Addendum No. 1

*Subject: Bid 2026-1 Dunes CDD Reverse Osmosis Feed Pump Replacement –
Addendum No. 1*

DUNES COMMUNITY DEVELOPMENT DISTRICT
REVERSE OSMOSIS
MEMBRANE FEED PUMP REPLACEMENT

CONTROL SYSTEM BLOCK DIAGRAM

I-3

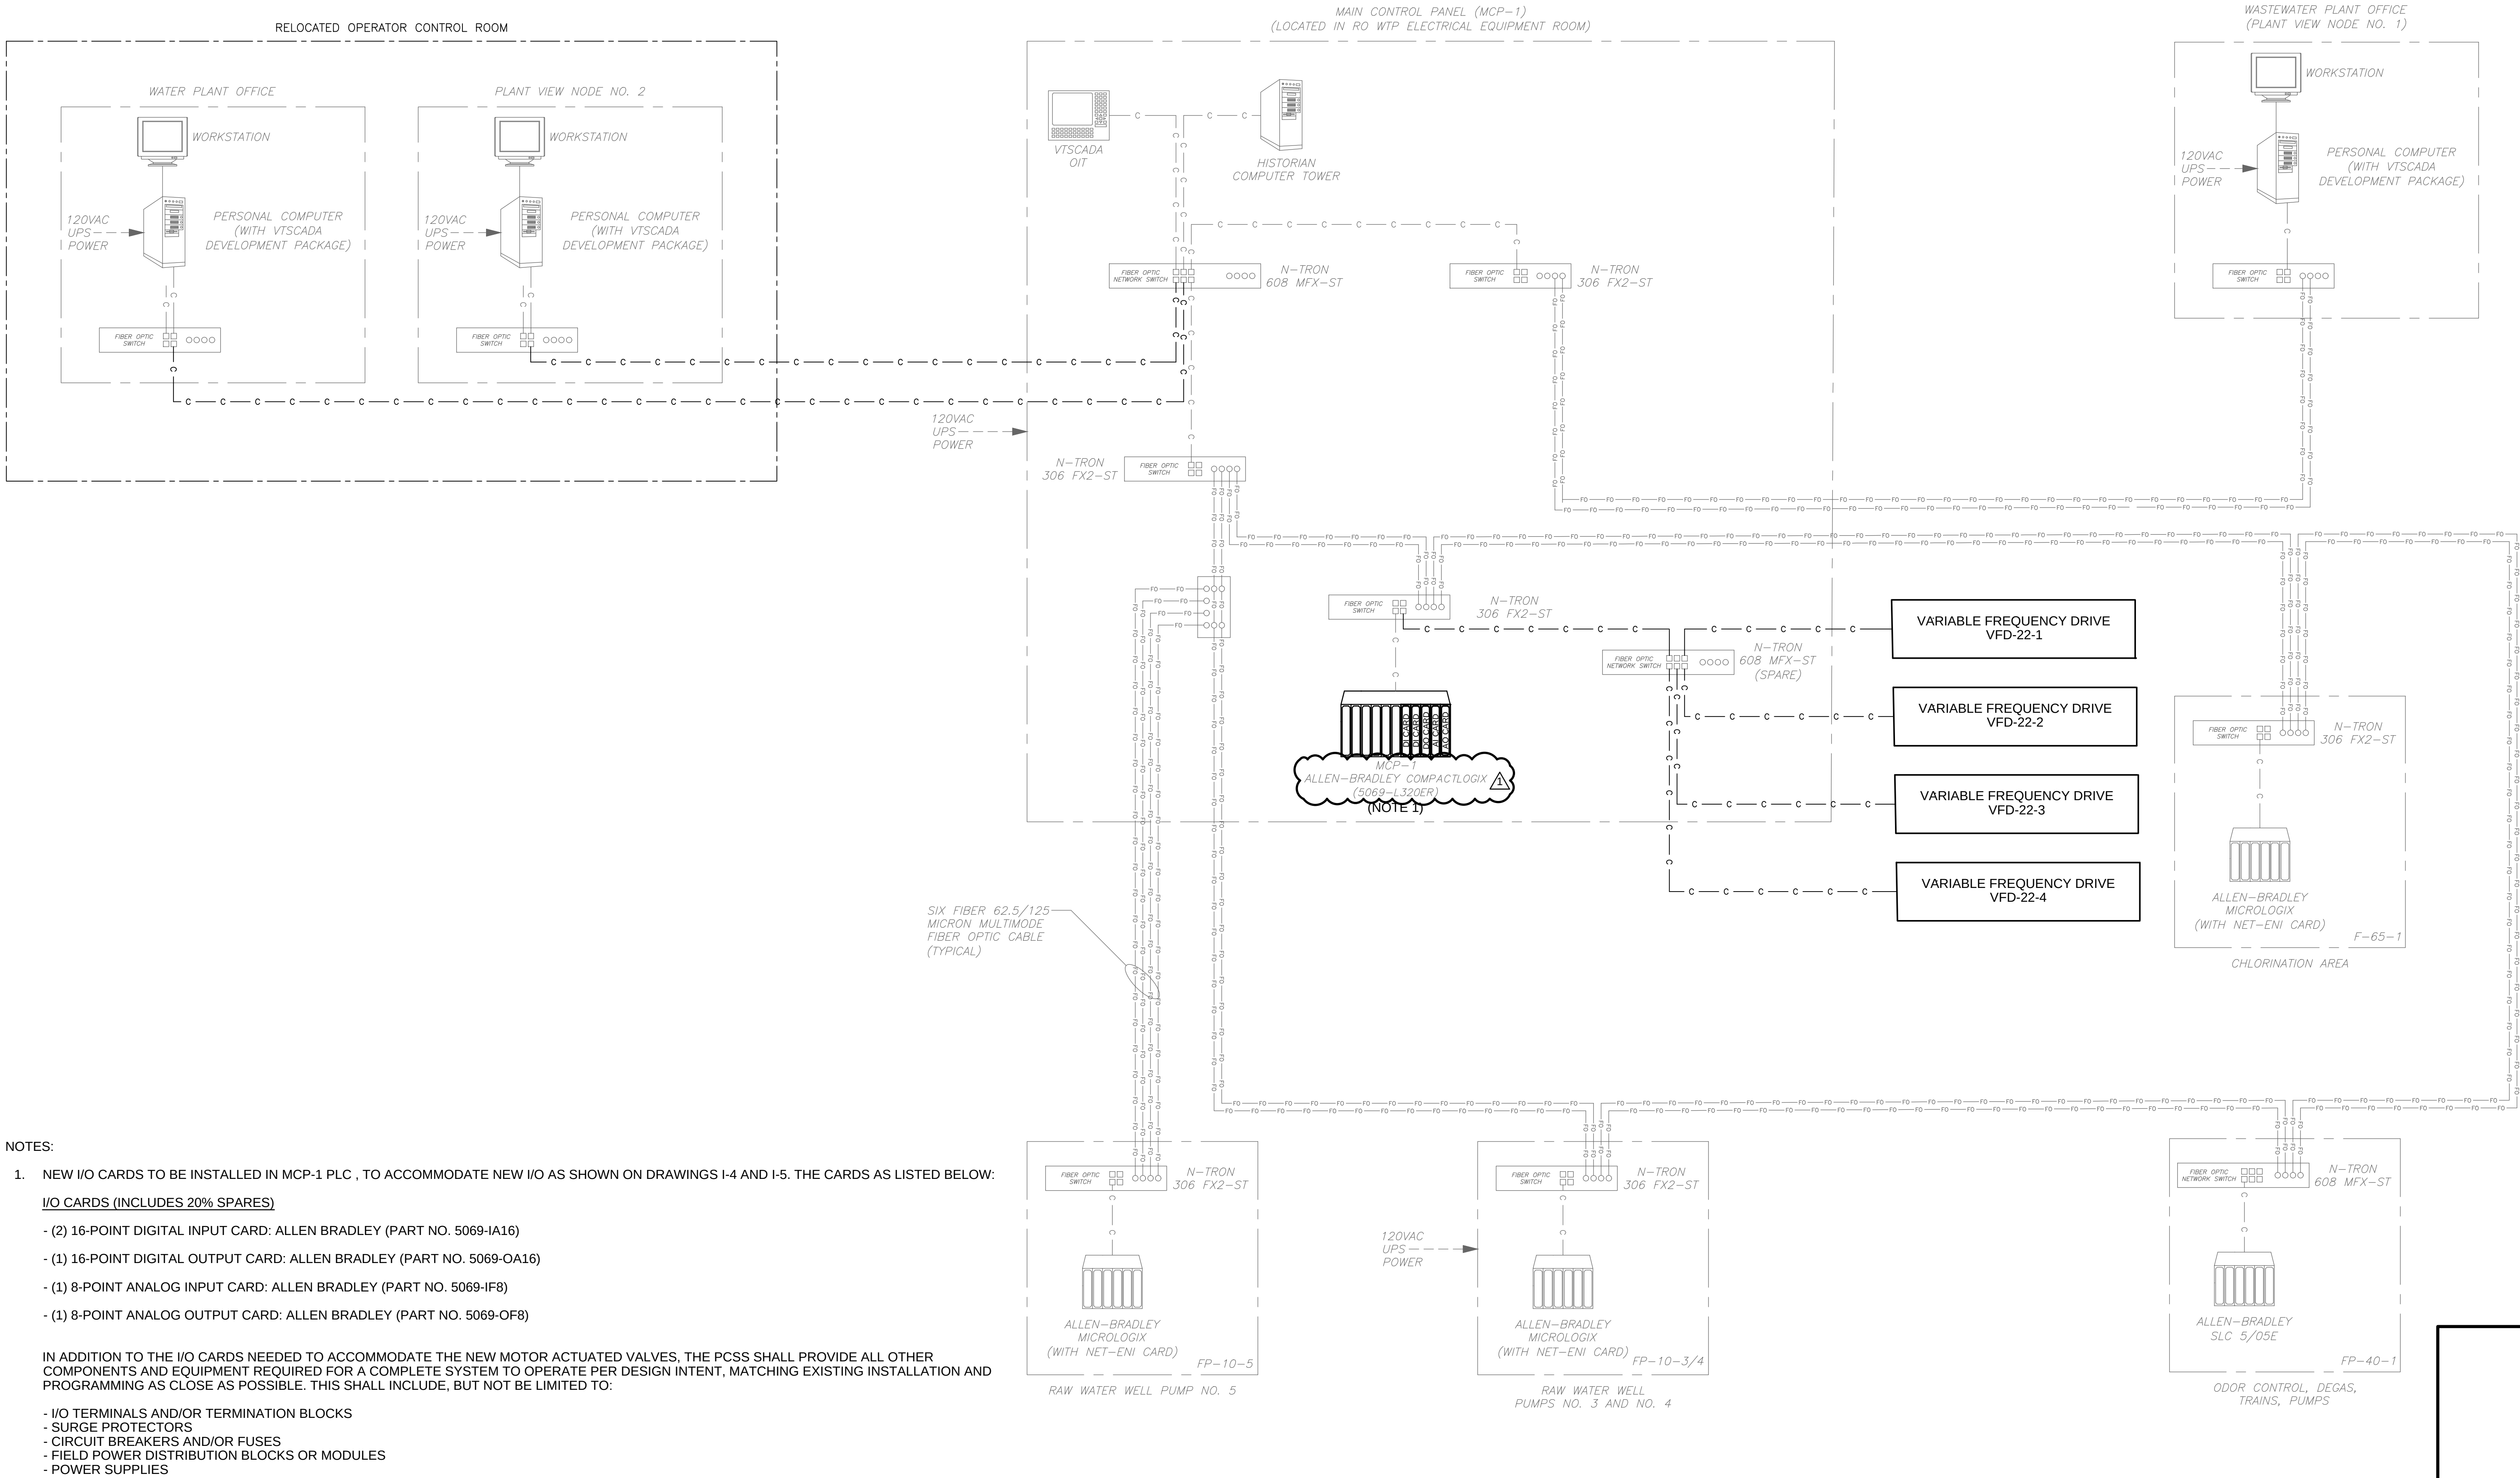
1. We did want to point out on the network architecture drawing that the PLC rack in MCP-1 is called out as a SLC 5/05E, but the cards you specify to add are CompactLogix cards. Our recent experience is that you can't get SLC cards anymore so either the SLC rack needs to be changed out for a CompactLogix as part of this scope, or it is already a CompactLogix and is simply mislabeled on the drawing?

Response: The PLC in that panel today is a CompactLogix 5069-L320ER. Sheet I-3 has been revised and is attached as Attachment 1.

Attachment 2: Pump Information

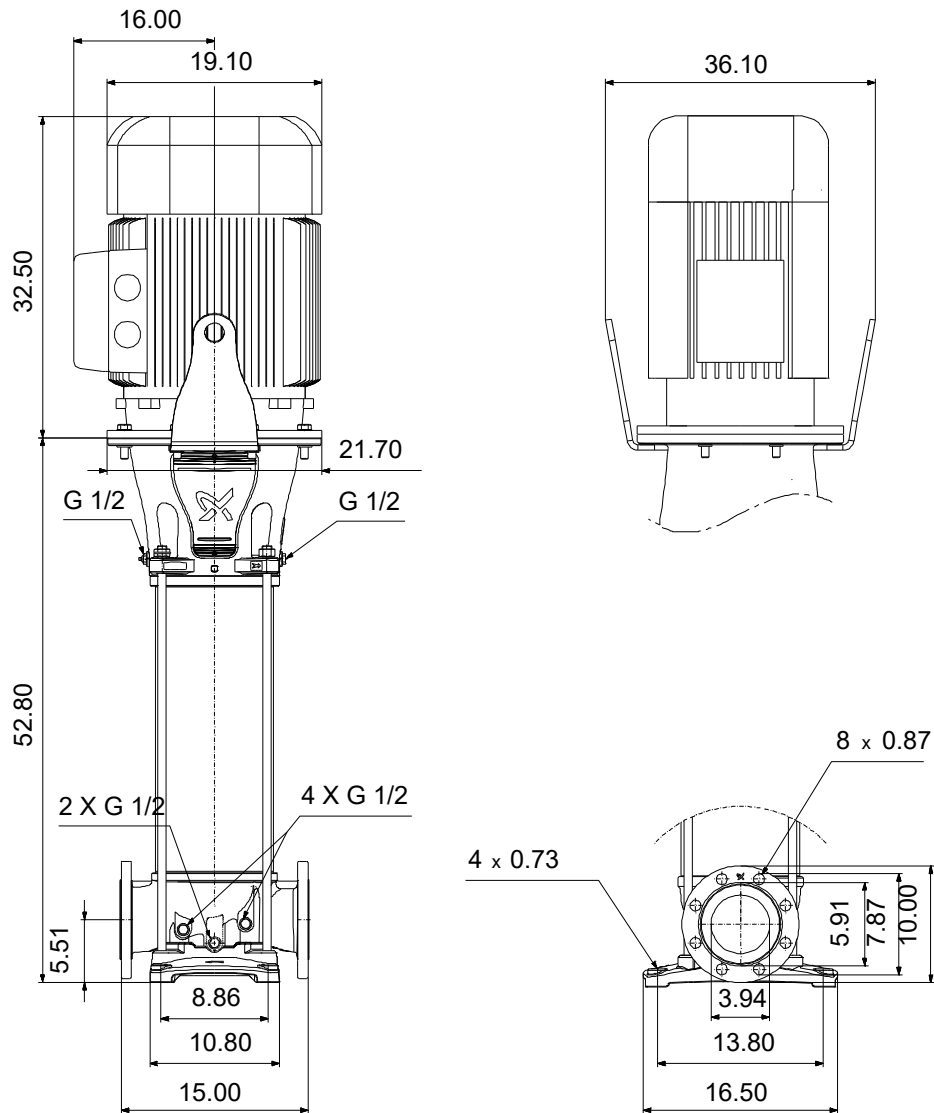
3. How heavy are the pumps?

Response: Pump vendor information is included in Attachment 2.

Afton Pumps: Pump Weight 585 lbs + Motor Weight 1,900 lbs = 2,485 lbs

Grundfos: Gross Weight = 2,090 lbs.
